SUBJECT: GEAR WARNING CIRCUIT & THROTTLE SWITCH MODIFICATION

AFFECTED: MOONEY M20J, S/N 24-3201, 24-3218 THRU 24-3402
MOONEY M20M, S/N 27-0001 THRU 27-0229
MOONEY M20R, S/N 29-0001 THRU 29-0110

FIGURE SI M20-103-1

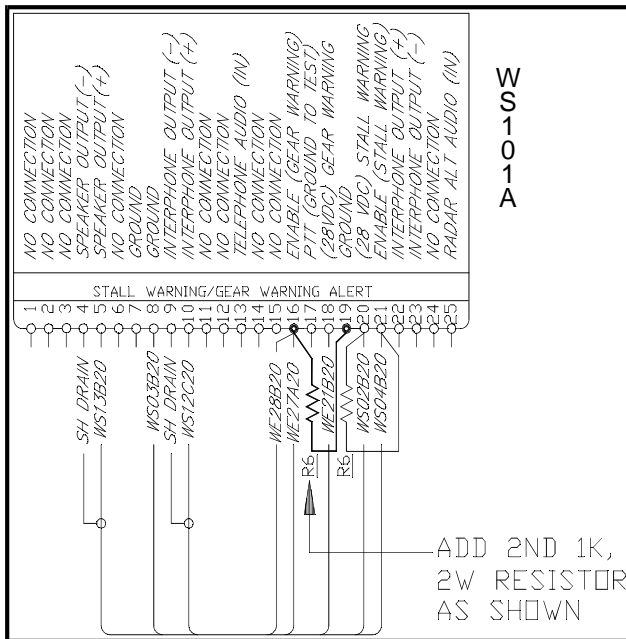
3. Reference schematic shown in Figure SI M20-103-1 and solder the MIL-R-11-RC42, 1K 2W resistor, (Allen-Bradley P/N RC42-GF102J, included in kit) between the designated pins (16 - ENABLE-GEAR WARNING and 19 - GROUND). The resistor must be positioned so it will not interfere with the connection of the wire harness back to the Tone Generator. Protect resistor with heat shrink or other insulation.

FIGURE SI M20-103-2

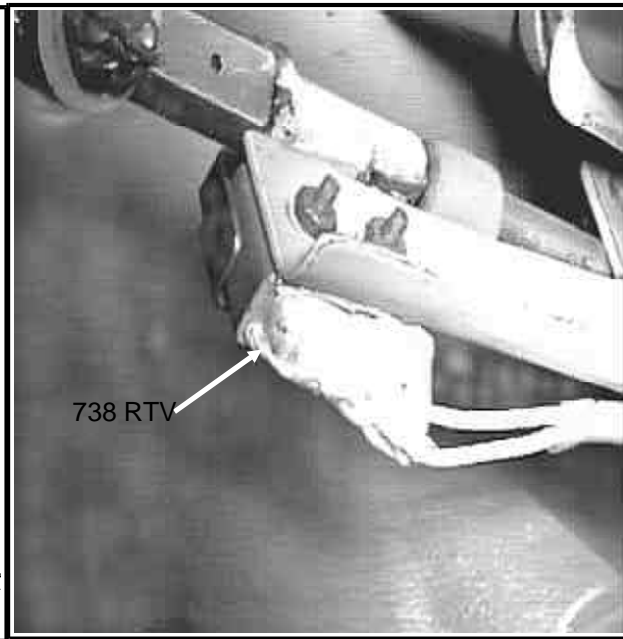
7. If no sealant is found or integrity is compromised, apply Dow Corning 738 RTV Silastic Sealant, covering wire/switch connections completely. Switch is Micro Switch P/N 1SE1-T. Reference Figure SI M20-103-2.

FIG. SW101A

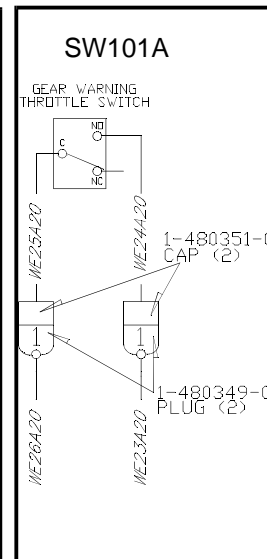
8. Locate 4 Pin Plug, RC04A/PL04A (on rear engine baffle) and replace with 2 each connectors, AMP P/N 1-480351-0 Cap (toward switch) and 1-480349-0 Plug. Reference Figure SI M20-103-3 & -4 for identification of wire numbers to change to AMP connectors. Discard clamp used on this 4 Pin Plug/Receptacle.
